**ST. MICHAEL'S AND ALL ANGELS CHURCH
(EPISCOPAL)**

PROJECT NO. 93049

PRESERVATION & RESTORATION PRELIMINARY OUTLINE NOTES

2 JUNE 1993

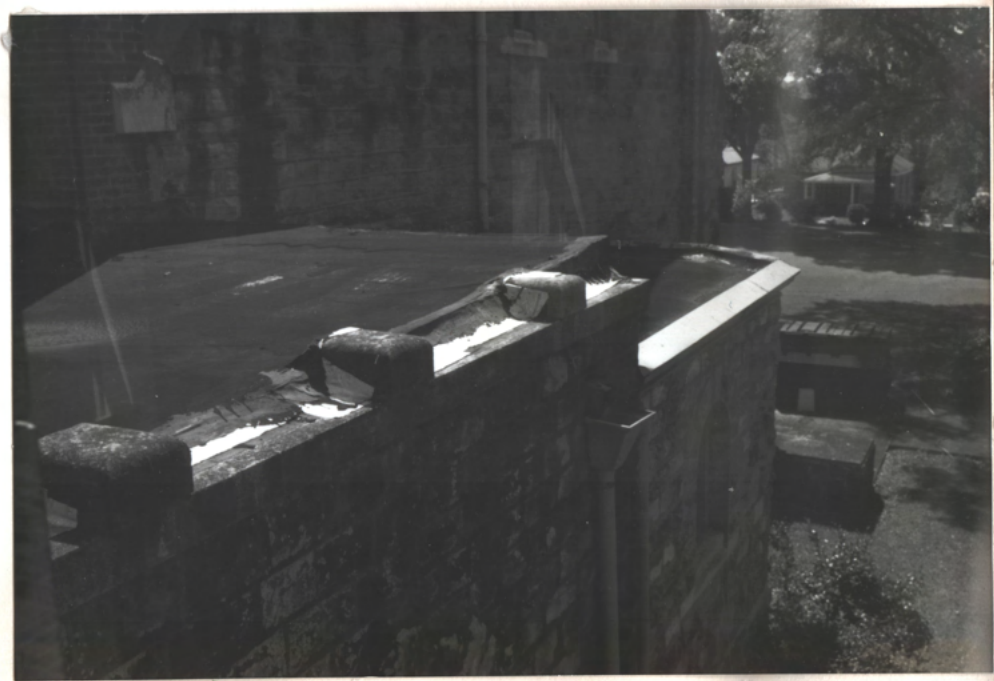
"Crickets" shed
(later?) w/
con. asbestos tile
on walls

Looks like single-ply roof (type?)
said installed in recent years

W. wall of S.E. - CR wing

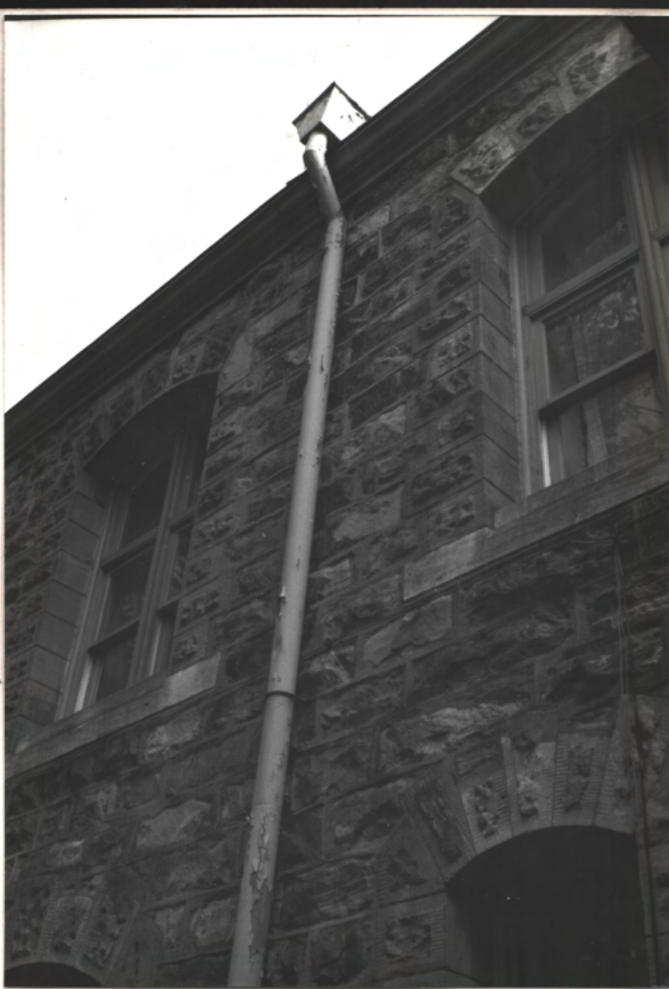
"Hump" in roof probably recent, to slope to ...

peeled
paint =
gals. not
cleaned
first, or
wrong paint
or both
(typical)

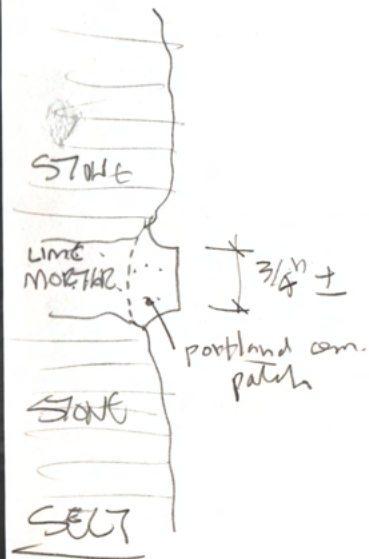
↑ not due to leaks in flat roof above + NW

PN
 LM. mortar = original lt. buff color
 lime mortar.
 Dark mortar = c. 1960
 portland cem.

17 of 25

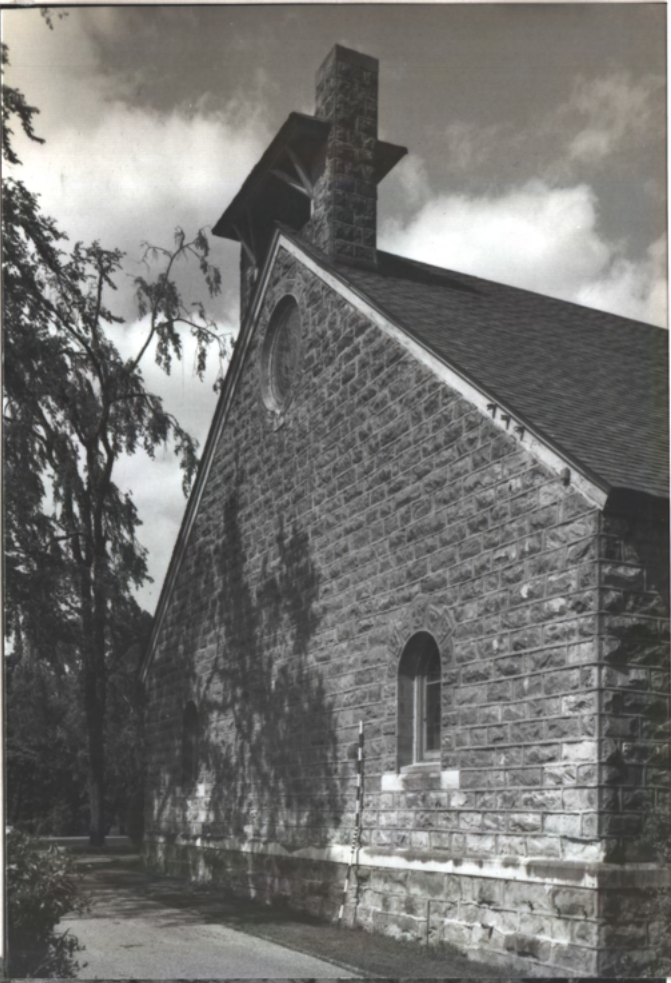
At S.W.
Corner:
entire face of
stone spalled
1/2" ± 1/2" deep
